MENAU DETENTION DAM

MENAU DETENTION BASIN AND STORM DRAIN (PHASE I)

APPROVAL OF AS-BUILT DRAWINGS
CHIEF CONSTRUCTION ENGINEER
Daniel B. Smith
DATE 4-20-95

ADDENDUM #2

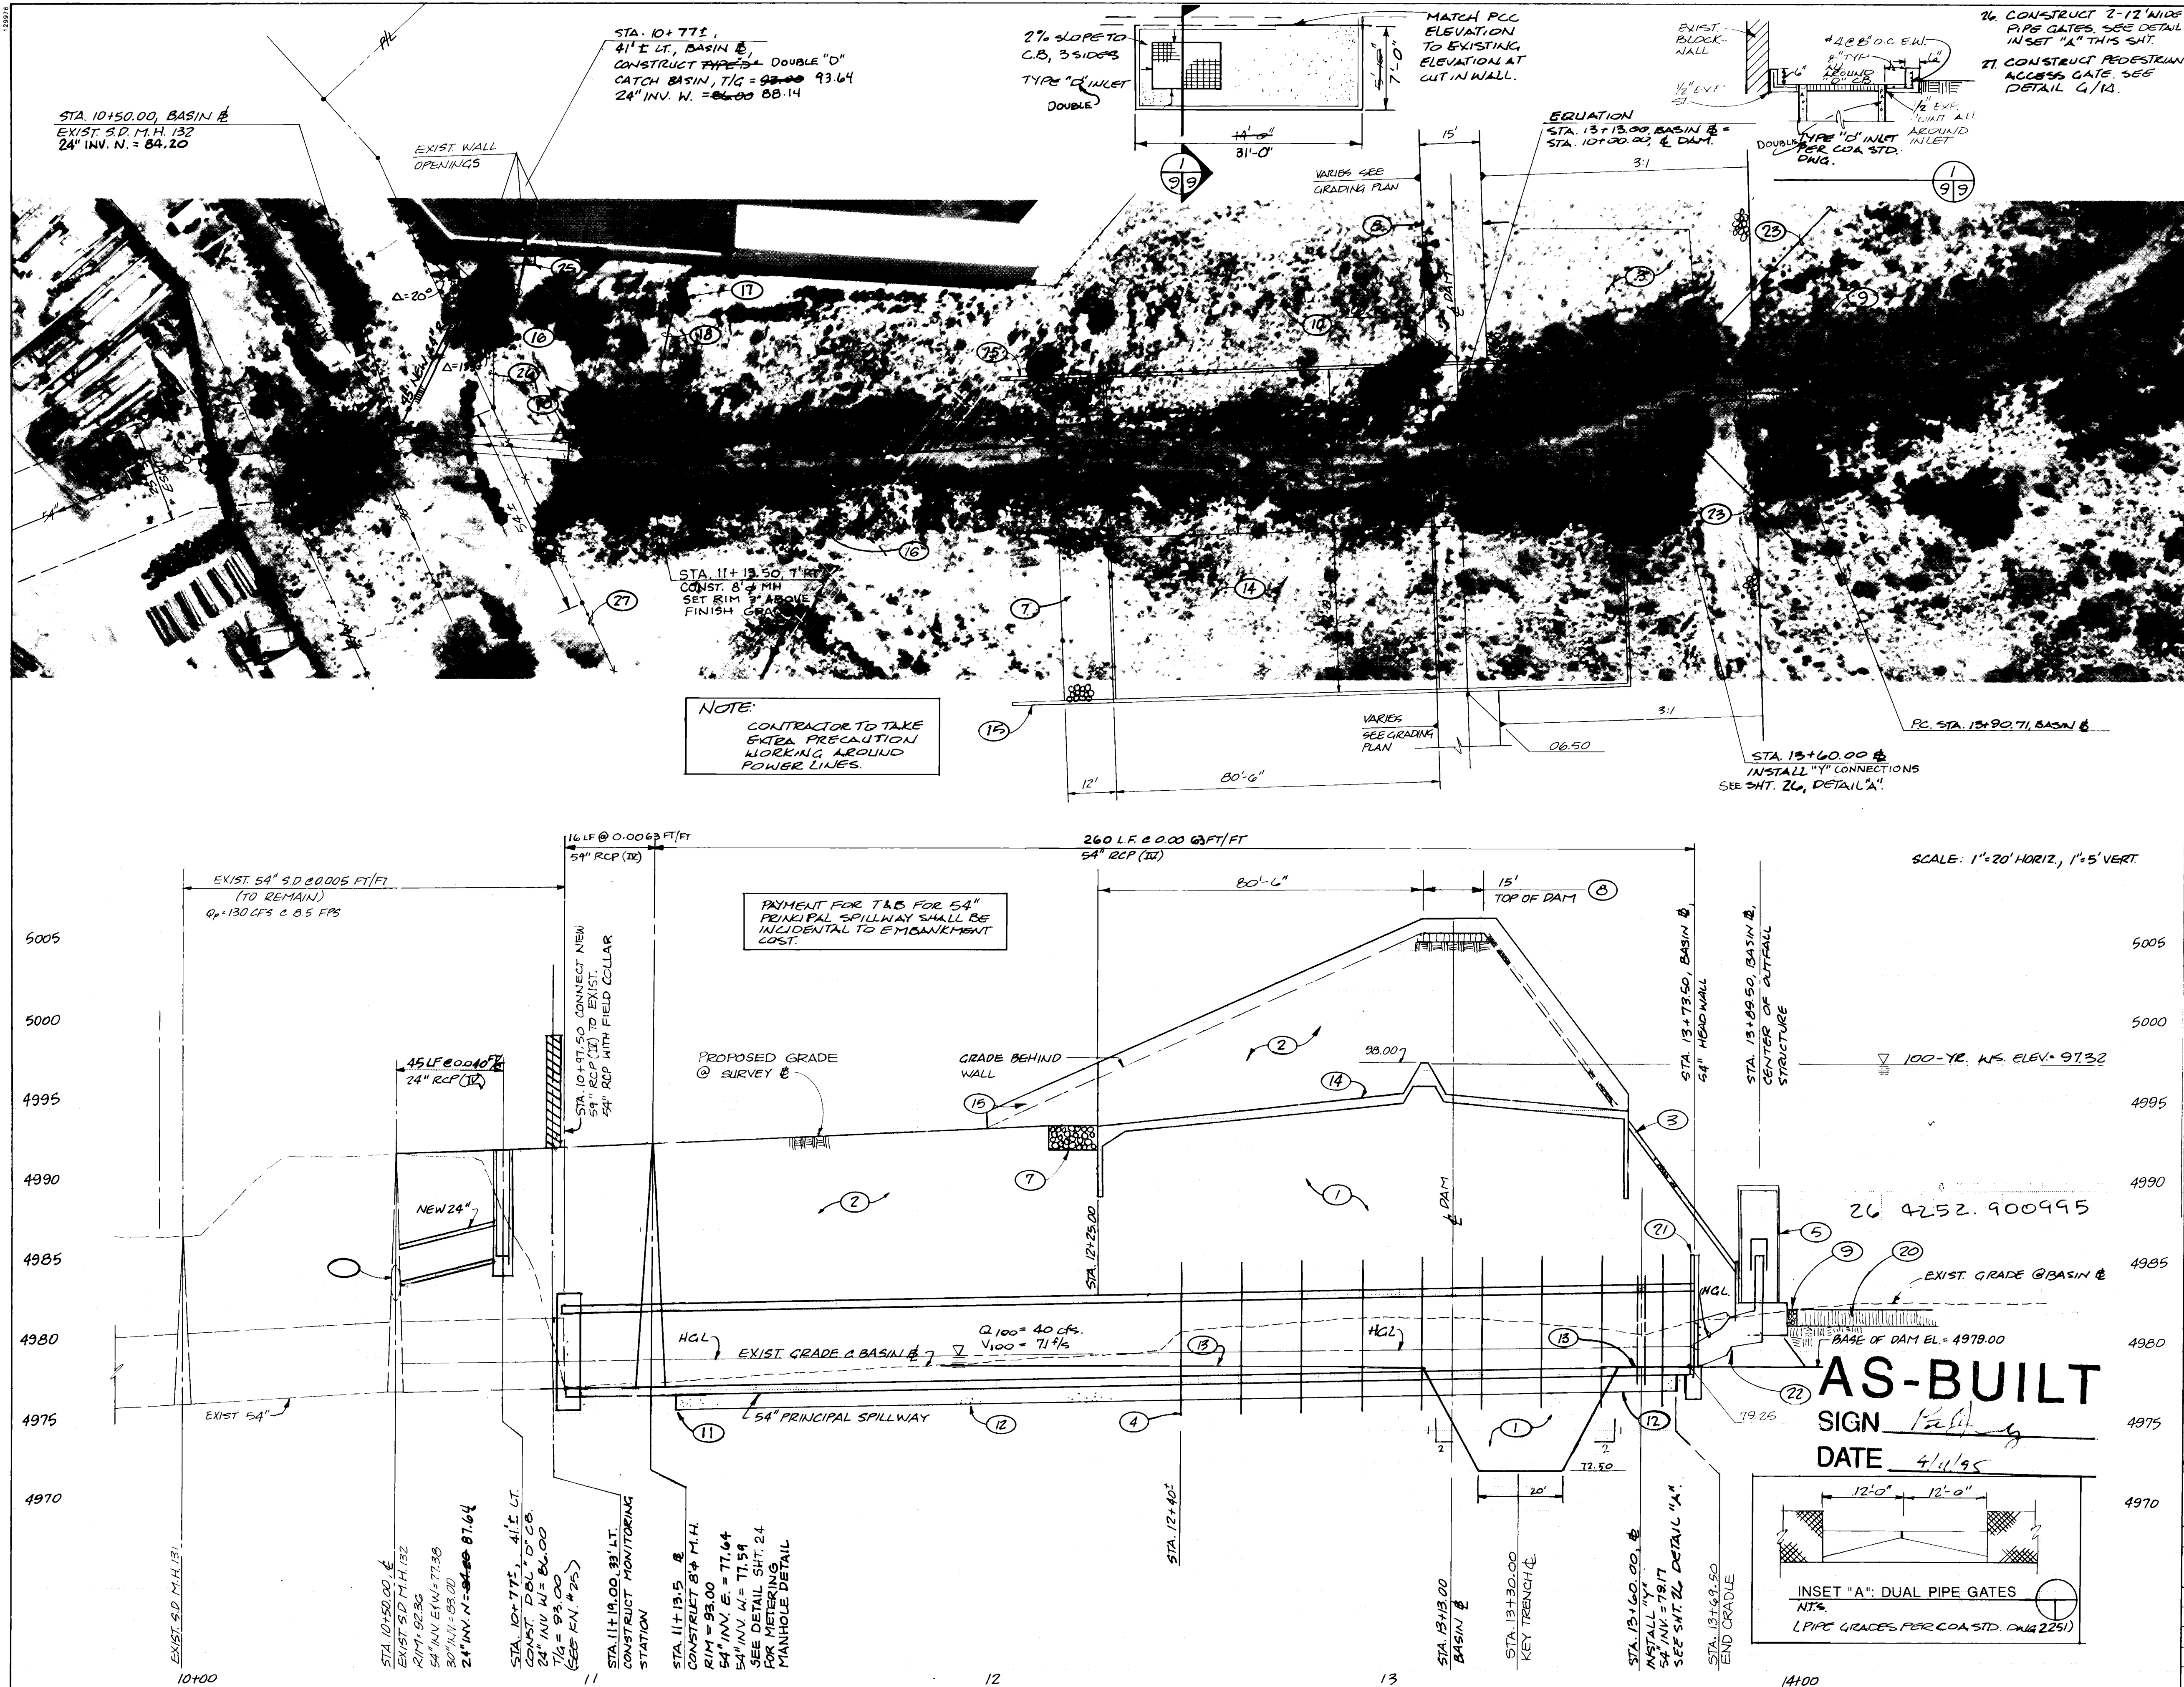
- EMBANKMENT FILL. COMPACT TO 95% ASTM D-1557.
- GENERAL FILL. COMPACT TO 95% ASTM D-1557.
- DAM FACE, SEE DETAIL F/13.
- CONSTRUCT CONCRETE ANTI-SEEPAGE COLLARS AT 16-FOOT O.C. SEE DETAIL A/14.

- CONSTRUCT TRASH RACK AND PRINCIPAL SPILLWAY. SEE SHEET 12 FOR DETAILS OF TRASH RACK.
- NOT USED
- CONSTRUCT CODE "D" GABIONS. STAKE PER COA DWG. 2270.
- CONSTRUCT 15-FOOT GRAVEL BASE COURSE ROAD. SEE DETAIL F/14.

- CONSTRUCT CODE "D" GABIONS NEXT TO PRINCIPAL SPILLWAY. SEE DETAIL A/12.
- CONNECT NEW 54" RCP TO EXIST. W/ FIELD COLLAR.
- BEGIN CRADLE @ STA. 11+20.
- CONSTRUCT PIPE CRADLE. SEE DETAIL C/14.

SHEET 16 OF 29

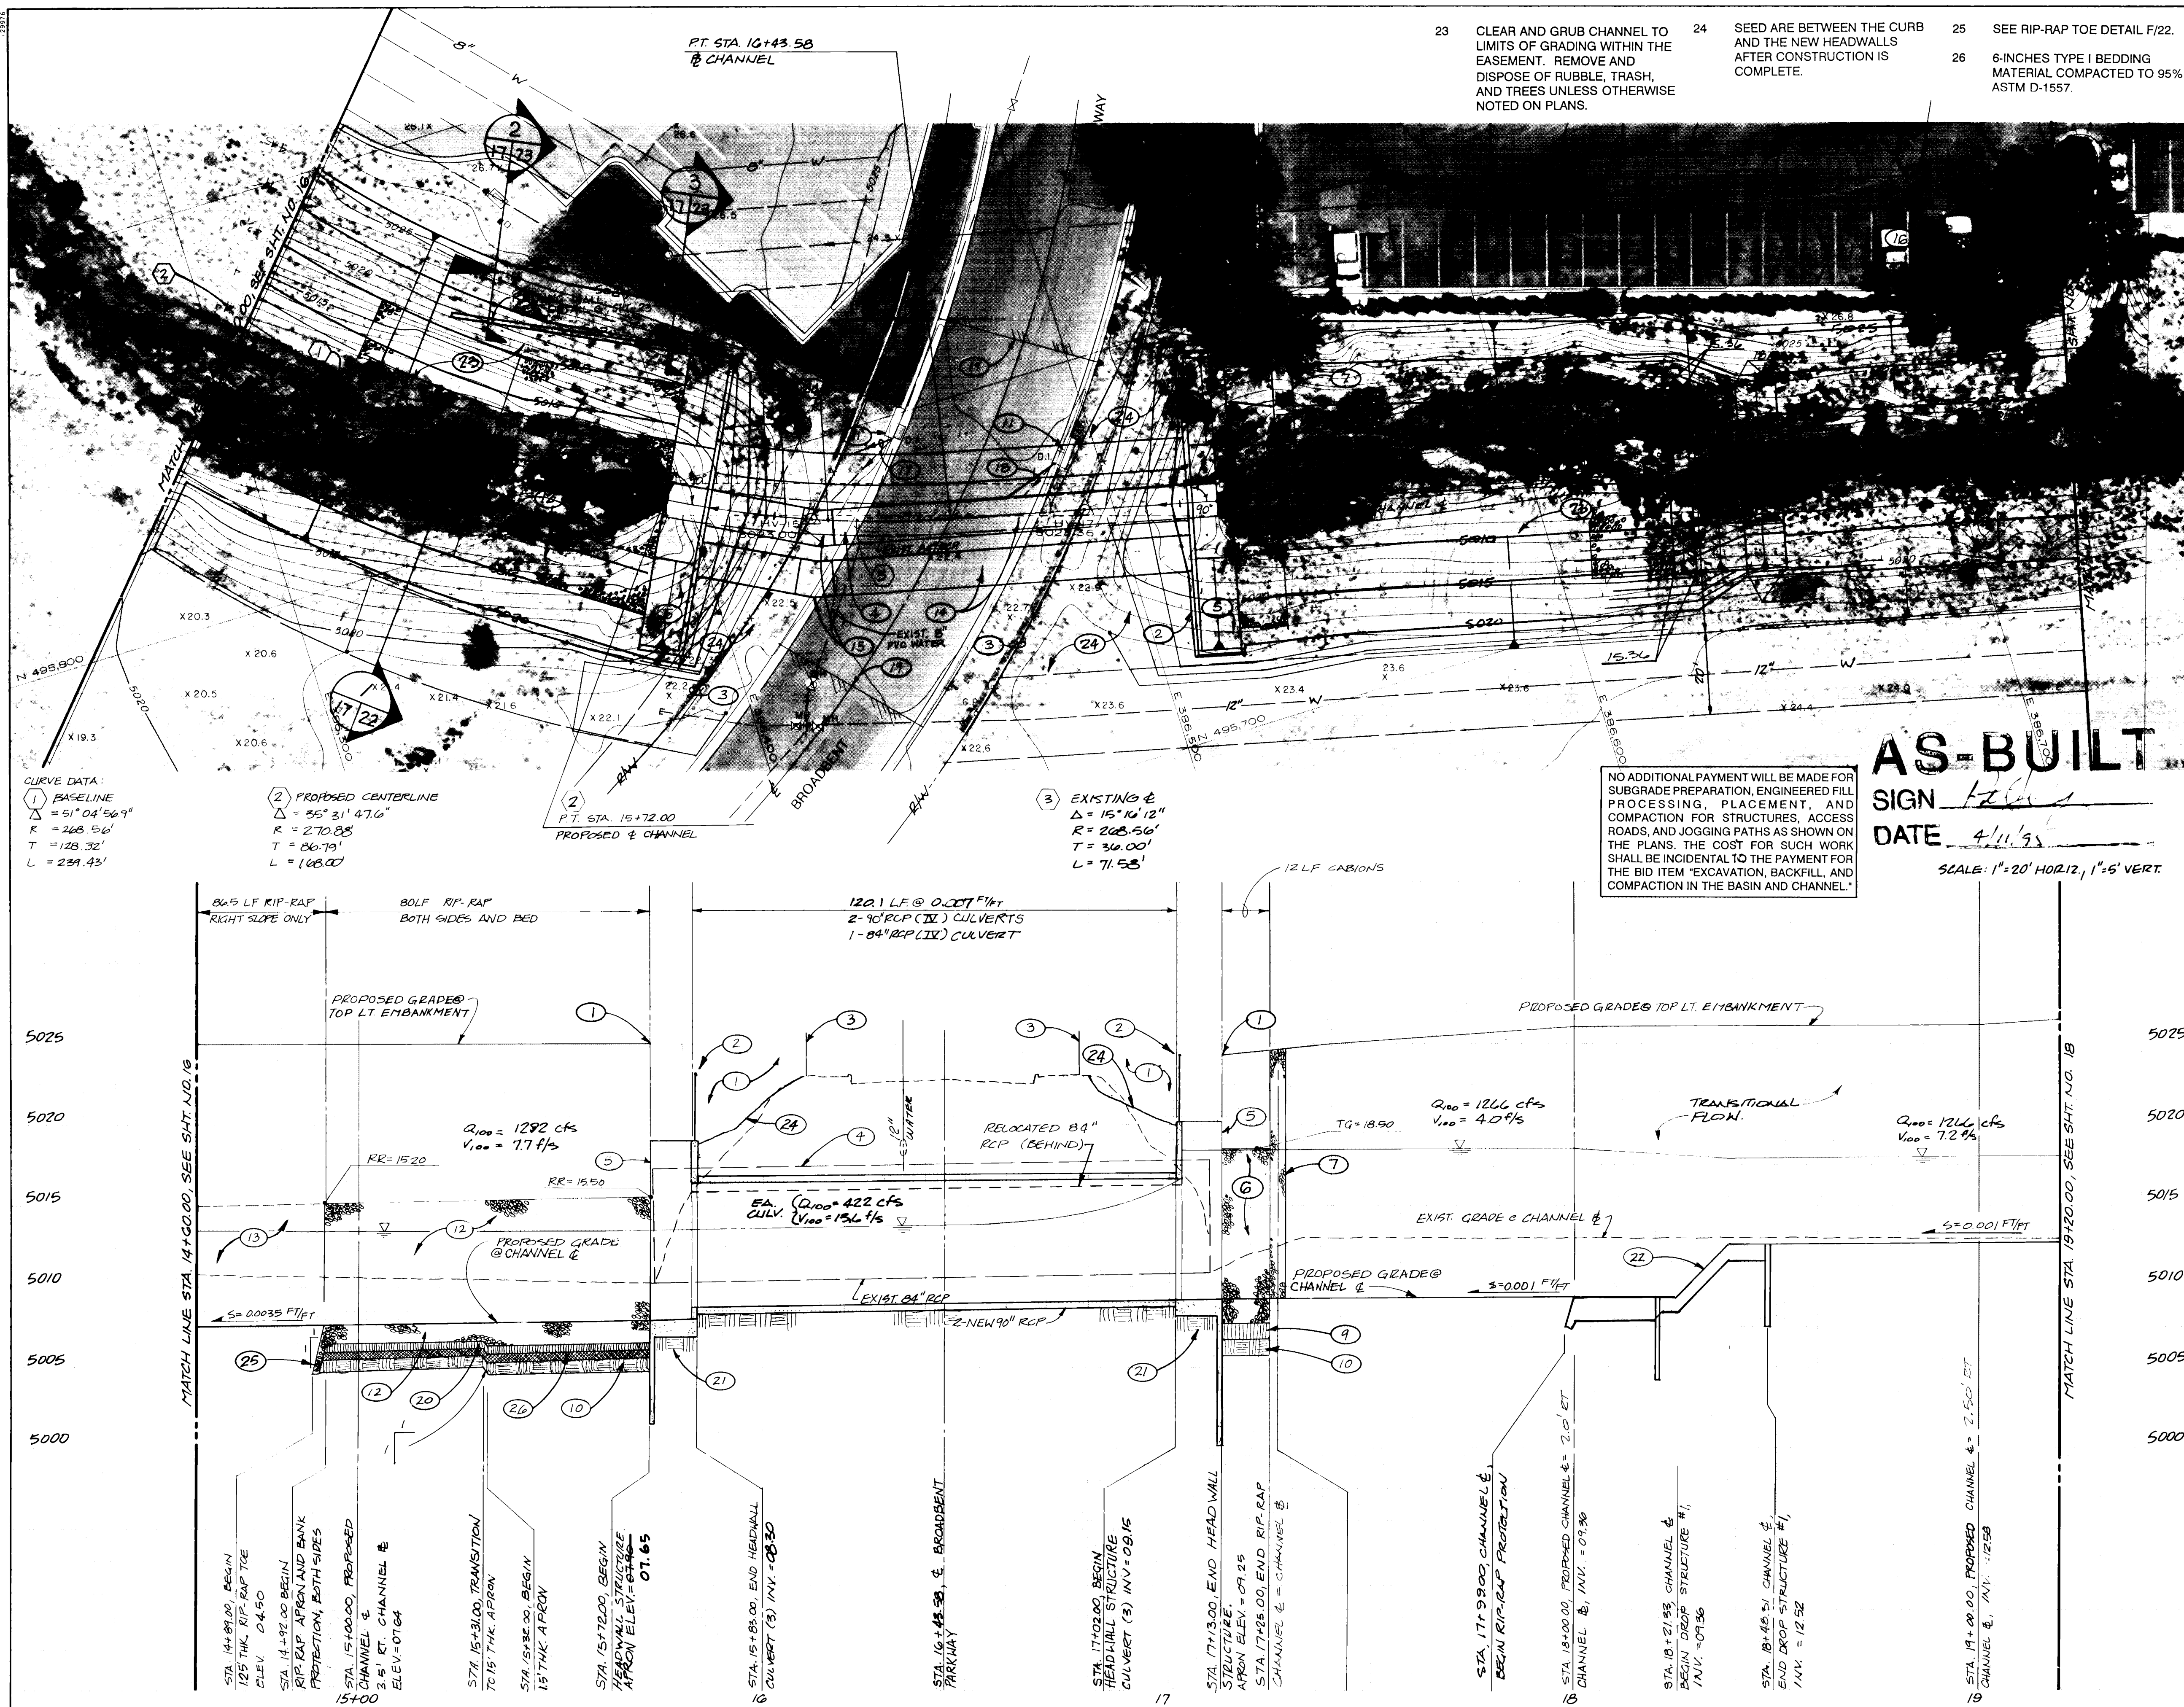
- SEE GRADING PLAN FOR CONTINUATION OF GRADES.
2. INSTALL ^{6 FT.} ~~48 INCH~~ HIGH CHAINLINK FENCE ALONG TOP OF HEADWALLS. SEE DETAIL E/23 FOR LOCATION OF FENCE POSTS.

5. CONSTRUCT HEADWALL. SEE DETAIL D/22 AND ELEVATION B/23.
6. CONSTRUCT CODE "F" GABIONS. ~~STAKE~~ PER COA DWG. 2270.
7. CONSTRUCT RIP-RAP RUNDOWN. ^{✓ GROUTED} SEE DETAIL B/22.

8. ~~NOT USED~~
9. ¹² ~~6 INCH~~ TYPE II BASE COURSE. COMPACT TO 95% ASTM D-1557.
10. 12-INCH SUBGRADE. COMPACT TO 95% ASTM D-1557.
11. REMOVE EXISTING CATCH BASIN AND CONNECTOR PIPE. CONSTRUCT NEW TYPE "A" CATCH BASIN. MATCH EXISTING GRADES AND INVERTS.
